## PRODUCT BULLETIN No. 225

### Euro Bracket Upgrade

315483  
EURO RAIL FIXING BRACKET  
PACK 4 - ALUMINIUM  
(SPD03068)

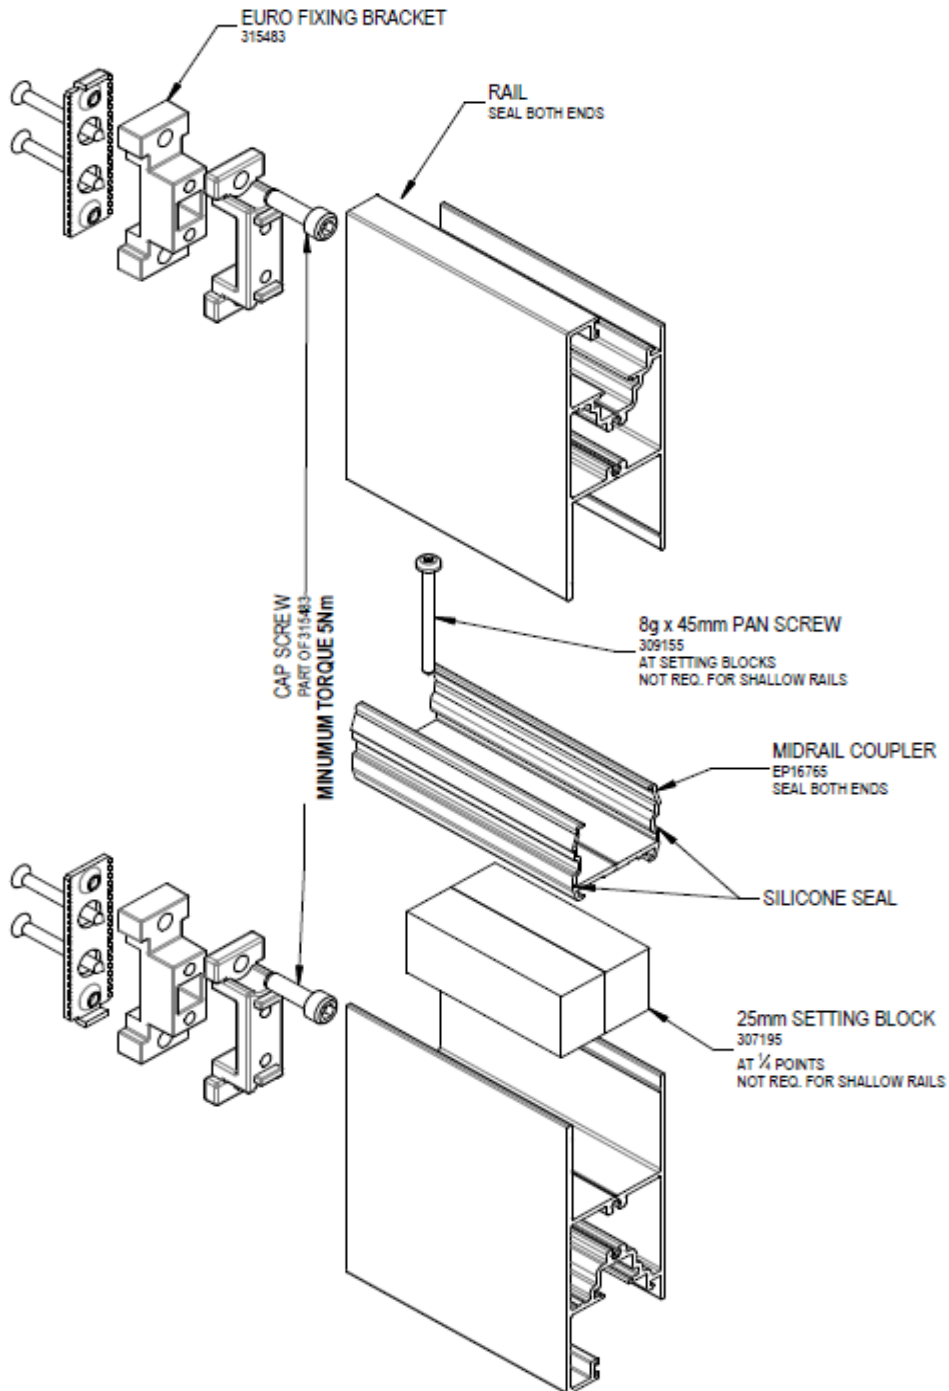
The serrated Stainless Steel plate as shown below has had two slight modifications,  
1/ The serrations along the side of the plate have been made more savage and full length.  
2/ A small stiffening element has been added to one end of the plate.

The small stiffening element can face inwards towards the glass or outward towards the outside of the panel except when using the Shallow rail (EP14962 & EP14963) where it must face towards the glass.

This is a running change to the component therefore fabricators will simply see a change to the plates supplied with the packs; these pack can be identified by the colour change in the centre support block to a WHITE colour.
